Part 5 Application **ACCESS REPORT**

Reference Number: 23349

26-28 Stevenage Rd & 53 Welwyn Rd,
Canley Heights NSW

Executive Summary and Design Compliance Statement

[Image description: Plan of Ground floor above shows the provision of Accessible parking spaces]

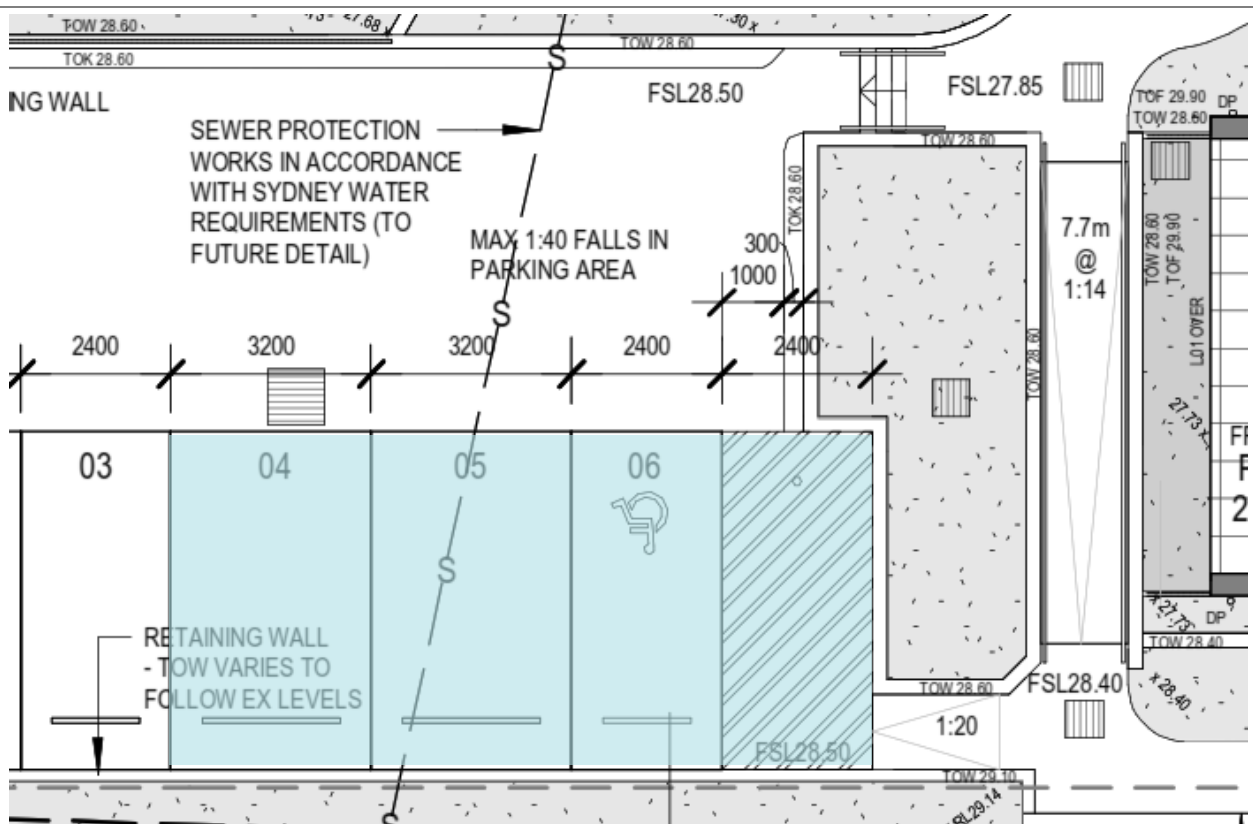
The development is proposed under the SEPP Seniors and a Person with a Disability. As such the SEPP sets its own requirements for carparking.

1 x AS2890.6 compliant parking space and 2 x 3.2m wide parking space out of the total of 6 parking spaces to fulfill the 50% required parking spaces to be accessible.

Pathways to Bus stop nominated by town planner

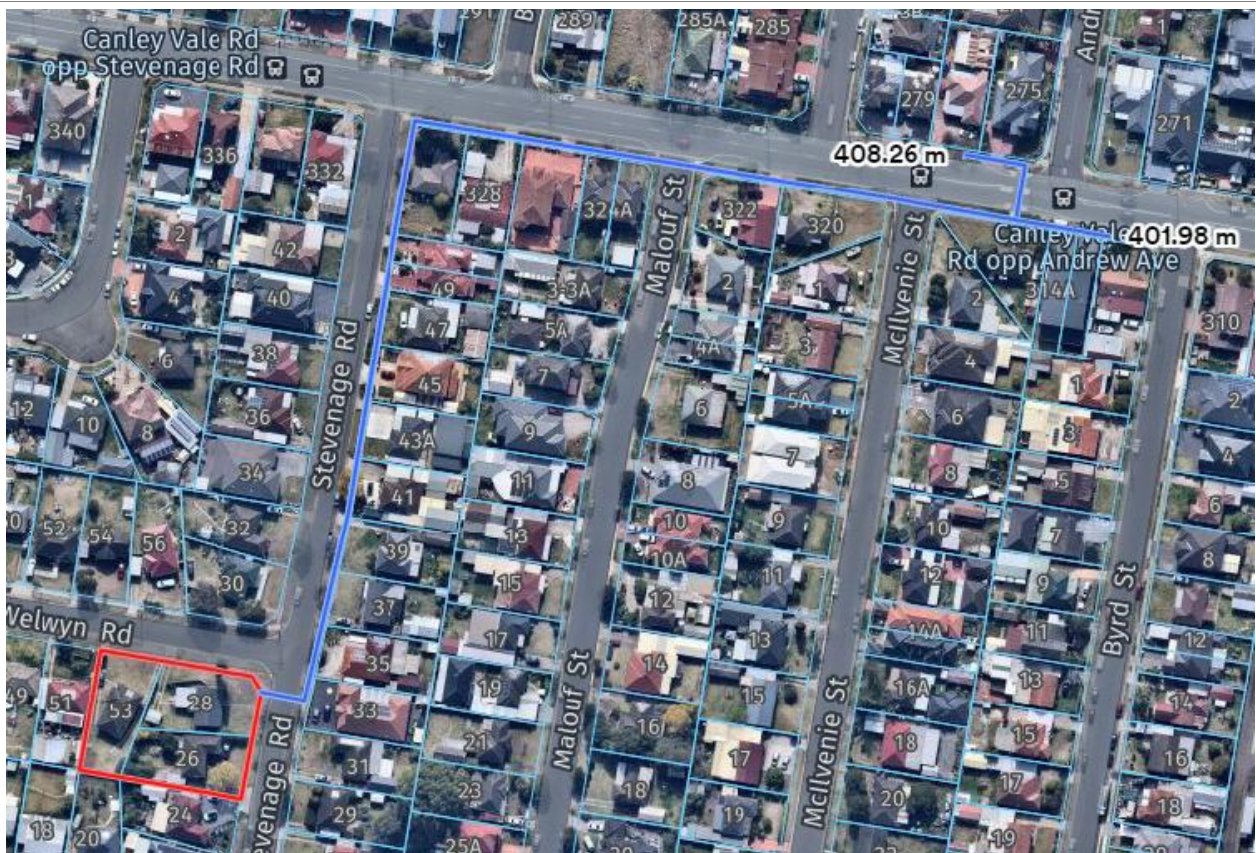
The distance to the bus stops (as identified by the client) from the subject site is approximately 408M and 402M as shown above. This is a very minor variation to the required maximum of 400M which is considered to be acceptable as it provides for a safer accessway than that provided to other bus stop options that may be closer to the subject site.

Item1:

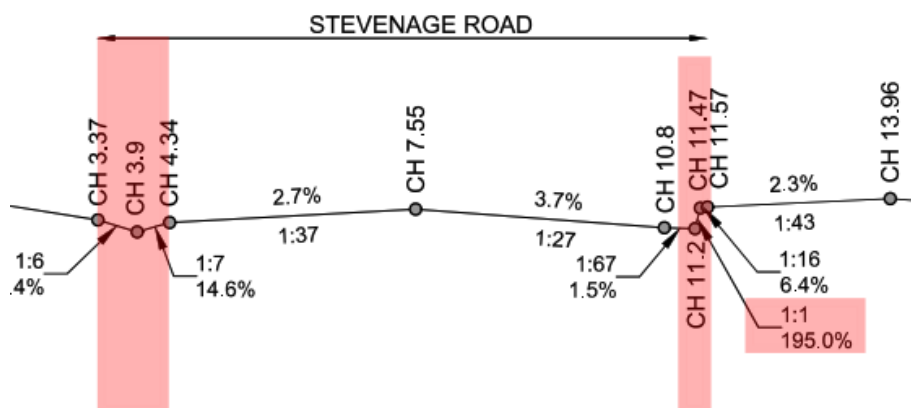
Path A – C based on the provided survey

Highlighted grade exceeds 1:8 grade, **New kerb ramps required**. The 1:8 grade to be no more than 1.5M at a time

Item2:

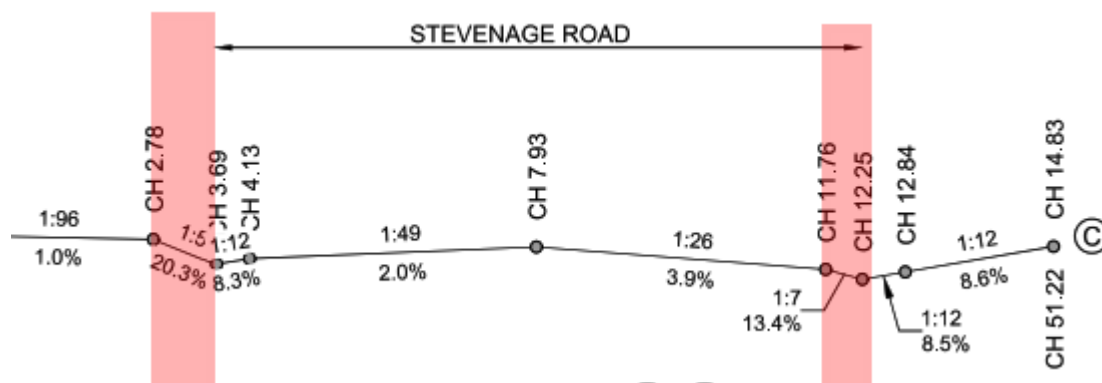
Path B – C based on the provided survey

Highlighted grade exceeds 1:8 grade, **New kerb ramps required**. The 1:8 grade to be no more than 1.5M at a time

Item3:

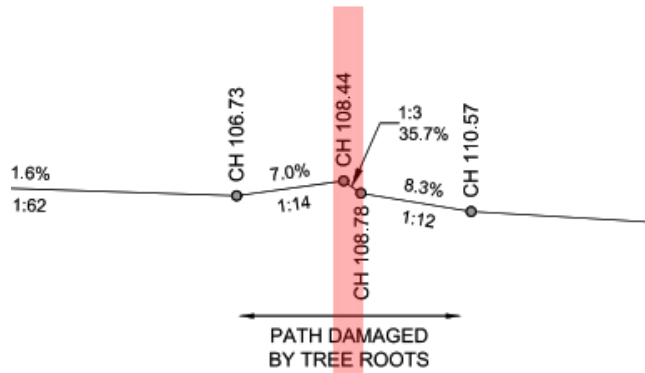
Path B – C based on the provided survey
Highlighted grade exceeds 1:8 grade. The 1:8 grade to be no more than 1.5M at a time

Item 4:

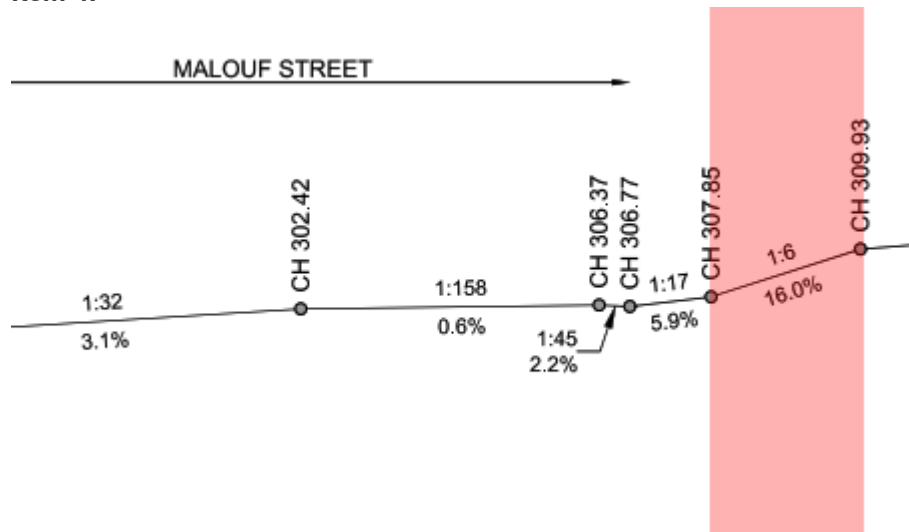
Path F-H-I based on the provided survey

Highlighted grade exceeds 1:8 grade. The 1:8 grade to be no more than 1.5M at a time

Item 5:

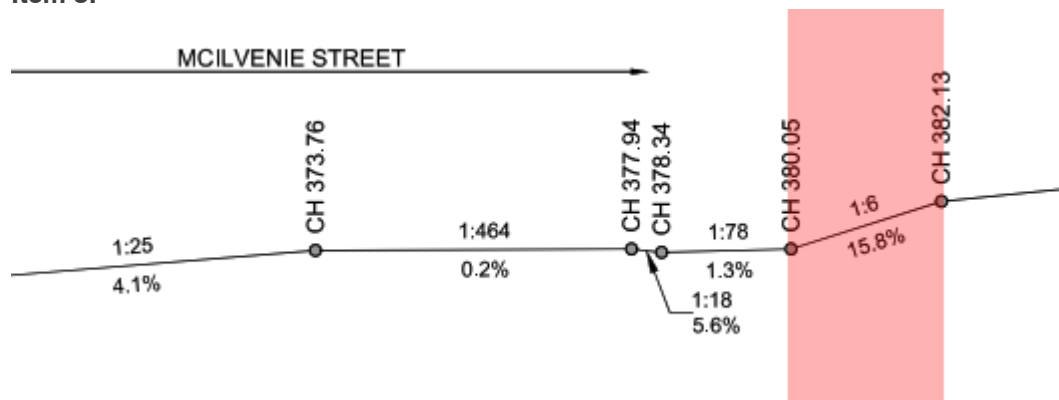
Path F-H-I based on the provided survey

Highlighted grade exceeds 1:8 grade. The 1:8 grade to be no more than 1.5M at a time

Item 6:

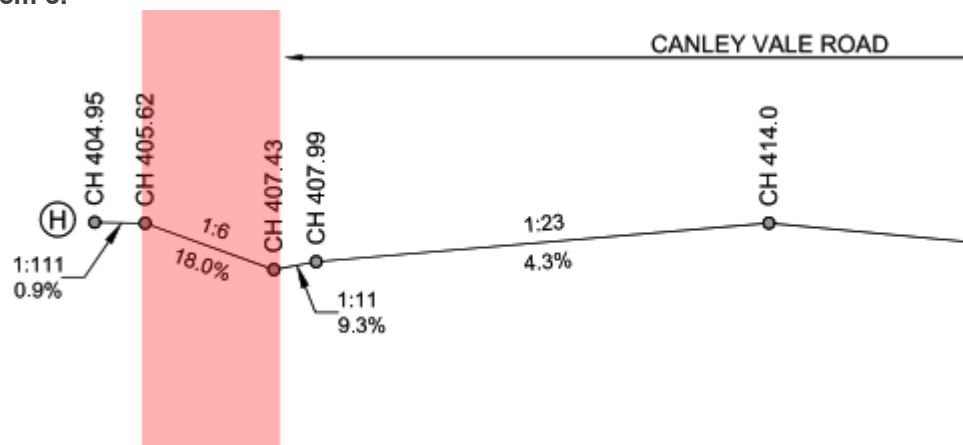
Path F-H-I based on the provided survey
